MWO 9-1005-319-20-2

MODIFICATION WORK ORDER

**MODIFICATION OF
RIFLE, 5.56MM, M16A4
(NSN 1005-01-383-2872)**

30 Nov 2006

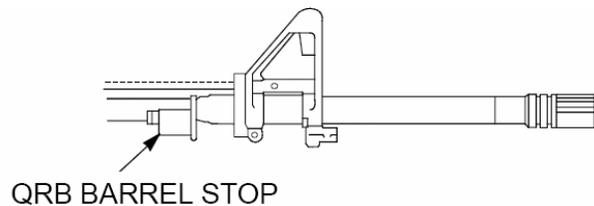
- (1) Loosen carrying handle nuts (1) but do not remove the nuts.
 - (2) After loosening nuts, clamp should be loose. Remove carrying handle (2).
- c. Removal of Handguards.

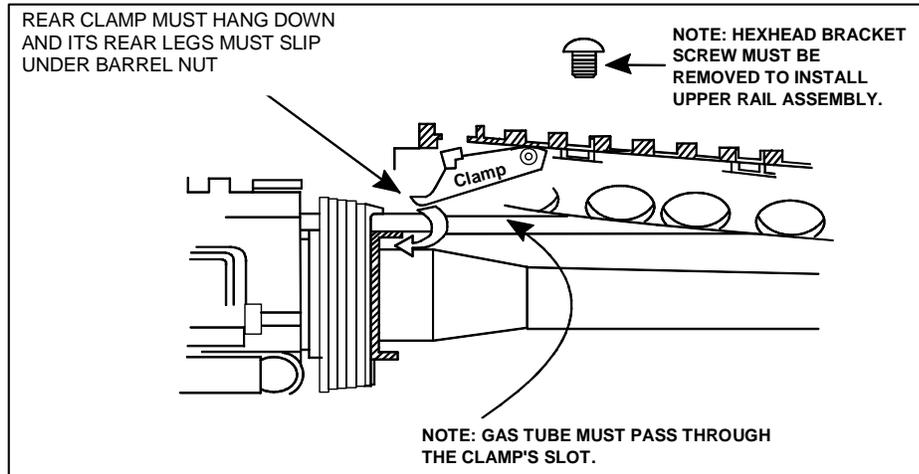
- (1) Install the stop by placing it over a thin section of the barrel from the six o'clock position, while avoiding contact with the gas tube.
- (2) Rotate it so its opening is pointed towards the gas tube.
- (3) Slide the stop forward until the flat vertical portion fits into the triangular sides of the forward hand guard cap with the springs to the rear.

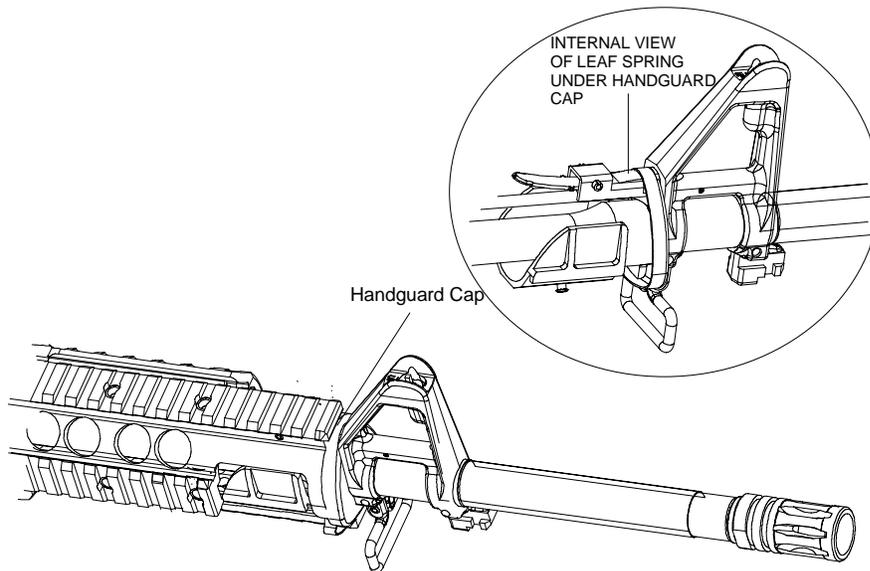
If the rear locking clamp screw is present in the clamp, it must first be fully removed with a 1/8 inch allen wrench.

- (1) Orient the upper adapter rail so the rear locking clamp is hanging down after confirming that the arrow on its inner surface points towards the muzzle of the host weapon.

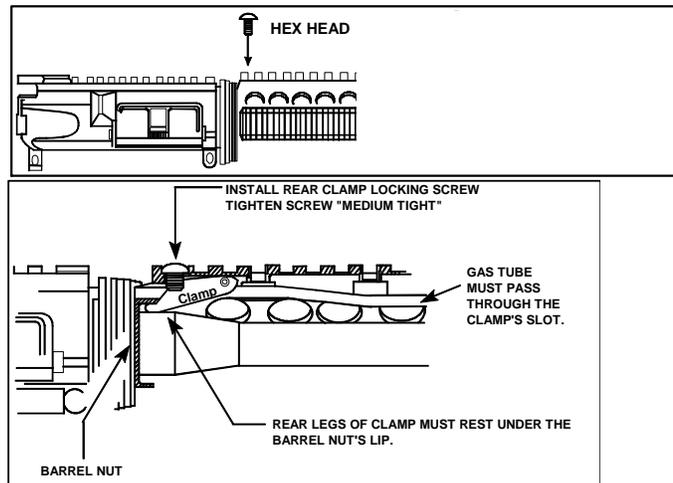
- (2) Insert the front end of the upper adapter rail into the forward handguard cap at an angle. Be sure the leaf spring at the front of the adapter rail fits inside the lip of the handguard cap.
- (3) Ensure the notches at the front edges of the rifle upper adapter rail engage the tabs at the rear edges of the barrel stop as the rifle is engaged and lowered into its final position.
- (4) Continue installing the upper adapter rail in the same manner as a standard upper handguard by compressing the handguard slip ring and pivoting the upper adapter rail down into its fully locked position around the barrel nut.

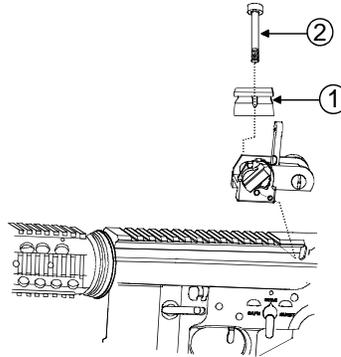
(1) Position rail cover so that the retaining clip is toward the muzzle.

(2) Depress retaining clip with thumb and slide on until the retaining clip locks into the end notch on the adapter rail.

(3) For the top rail cover, position retaining clip towards the rear, depress retaining clip, and slide on from the rear of the weapon until retaining clip locks into end notch.

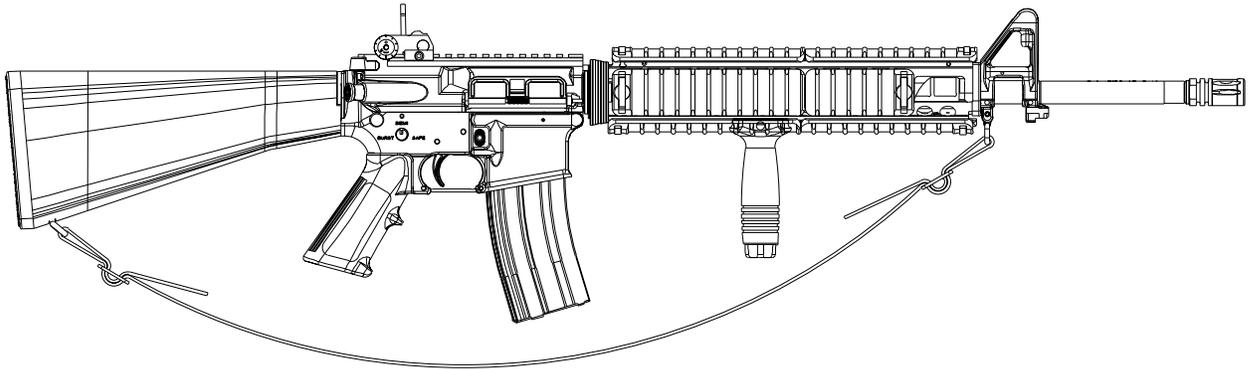
15. MODIFICATION IDENTIFICATION. Visual verification of application can be made as shown in illustration.
